**Subject:** DA2022/0857 Demolition of an existing dwelling and construct new dwelling and swimming pool at 28 Goondari Road Allambie Heights

## Response to DA2022/0857 Submission

Regarding: DA2022/0857

Photo 8 – View from Proposed Patio towards the House at no. 26

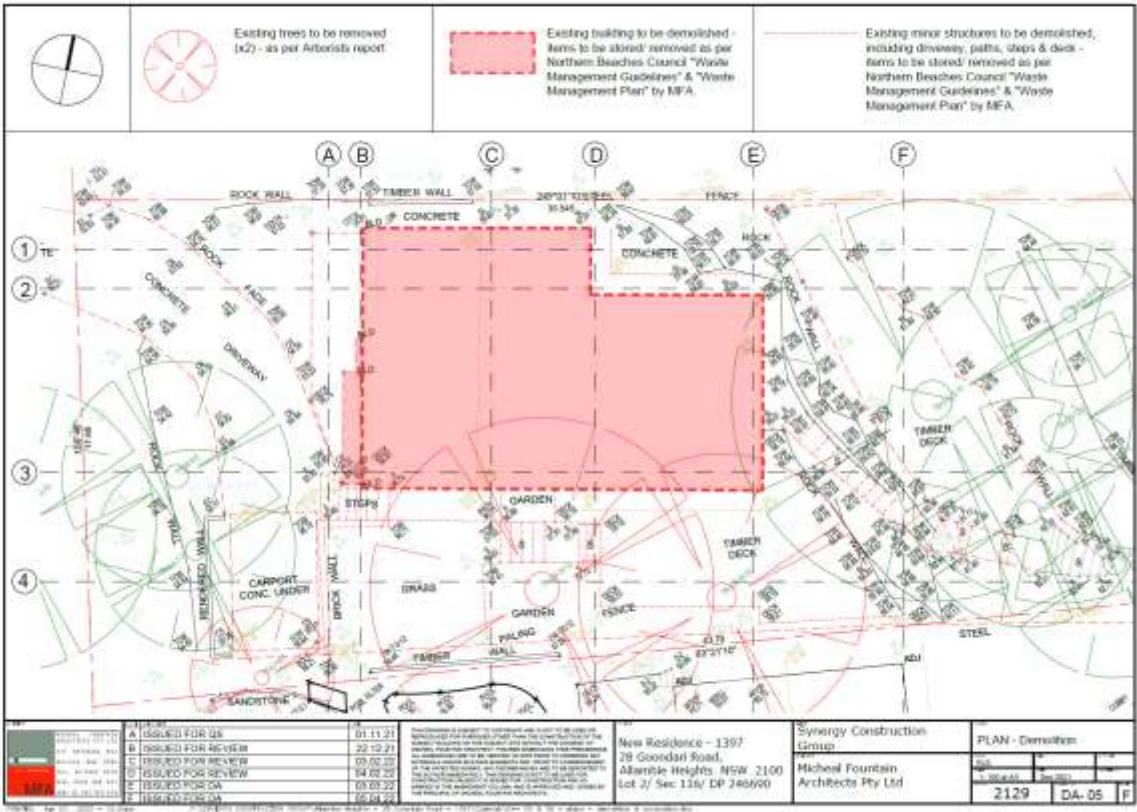
Refer [Photo 8](#) for a photo taken on the boundary line and at the elevation of the top of the balustrade (1.2m above patio floor) for the proposed patio – towards the house. Actual view of an adult (~1.8m tall) standing along the balustrade would be from a higher angle than shown.

Photo 9 – View from Proposed Patio towards the pool at no. 26

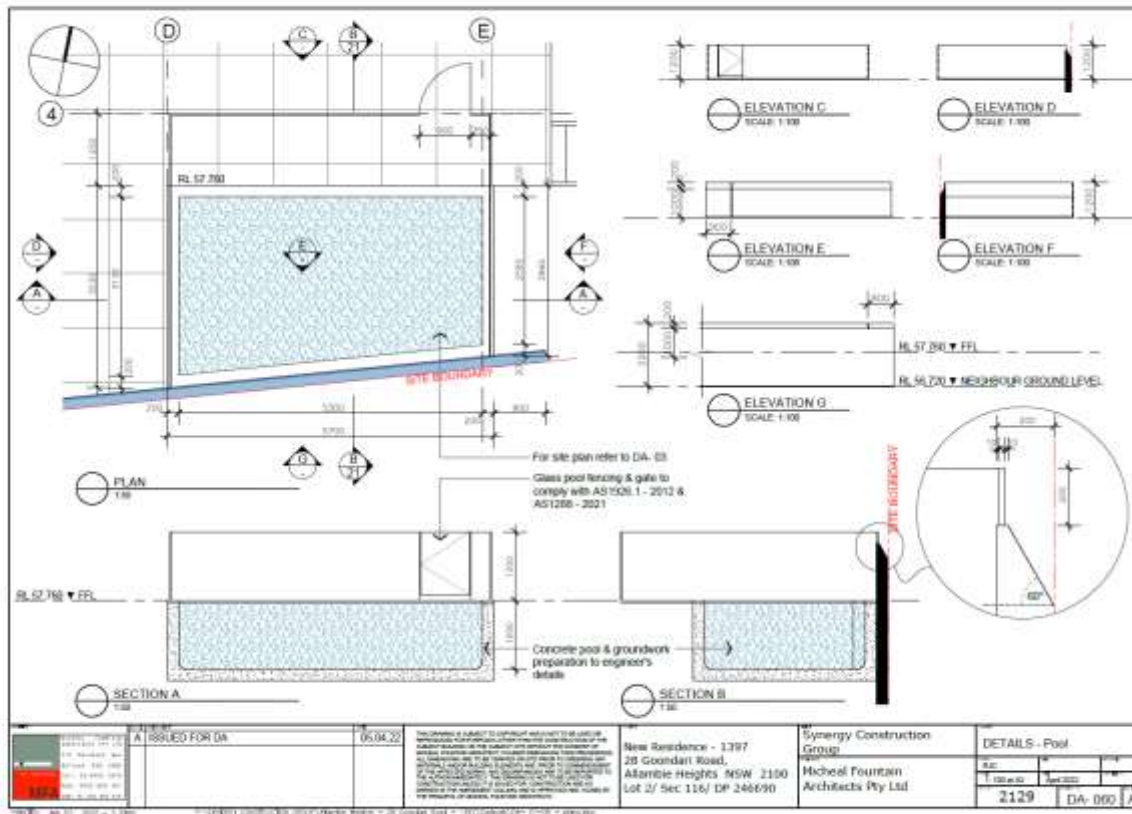
Refer [Photo 9](#) for a photo taken on the boundary line and at the elevation of the top of the balustrade (1.2m above patio floor) for the proposed patio – towards the swimming pool. Actual view of an adult (~1.8m tall) standing along the balustrade would be from a higher angle than shown.

Enlarged view of Elevation G showing estimated slope of neighbouring footpath

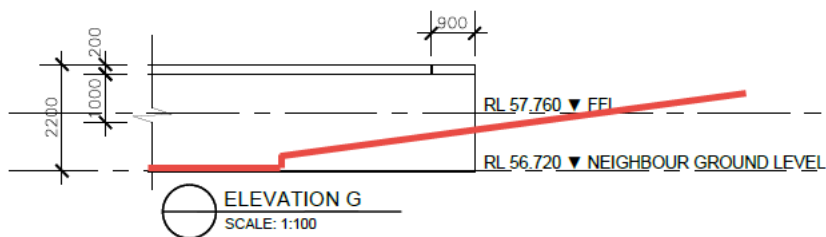
**Issue #6** – Slide 19 in the *Plans\_-\_Master\_Set.pdf* show misleading elevations in relation to the boundary between no. 26 and no. 28. Elevation G shows a flat neighbouring ground line at elevation 56.720, but we actually have a sloping footpath on this side of our house. The elevation of 56.720 is only applicable to western half of the proposed swimming pool and from the halfway point the ground slopes upwards towards the east. It is estimated that at the eastern edge of the swimming pool water (not including the 900mm outcrop of retaining wall), the height of the retaining wall and the 200mm glass topper will only be 1700mm, resulting in an un-obstructed view line between the swimming pool and persons on the footpath which would be a privacy concern for both parties I imagine.

Refer [Slide 19](#) in below appendix for detail of Pool elevations, and an illustration of the estimated elevation of the sloping footpath.

Illustration 2 – Artists impression of Garage and Patio Balustrade directly above swimming pool at no. 26.

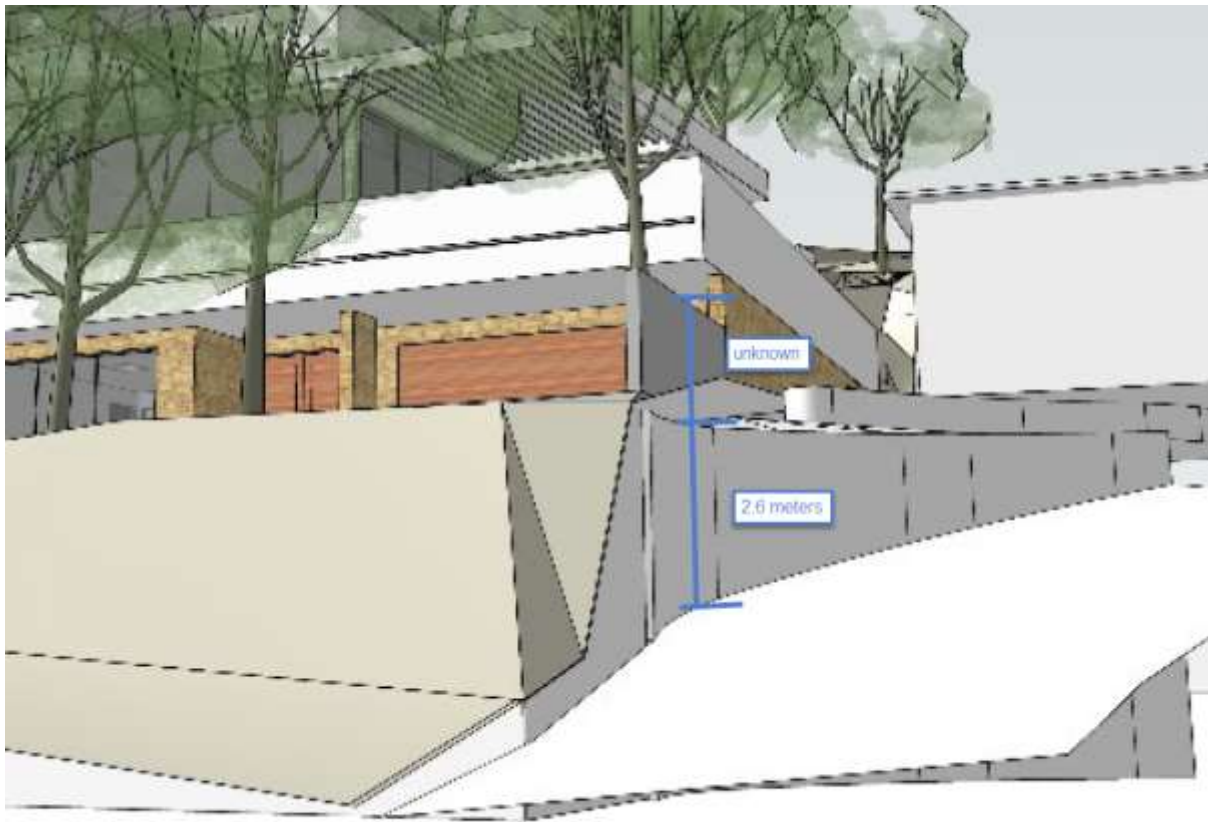
**Issue #11** – The development is calling for the new garage wall and the balustrade for the ground floor patio area to be constructed right on the boundary line. With the elevation of the swimming pool at 55.80 and the top of the patio balustrade at 58.80, this will result in a 3m high wall face along the edge of the swimming pool. This poses a serious risk of someone or something falling directly into the swimming pool from a height, and would be a safety concern for the swimmers using the pool at no. 26.

Refer [Illustration 2](#) in below appending show artists impression of the new wall being placed on the boundary.
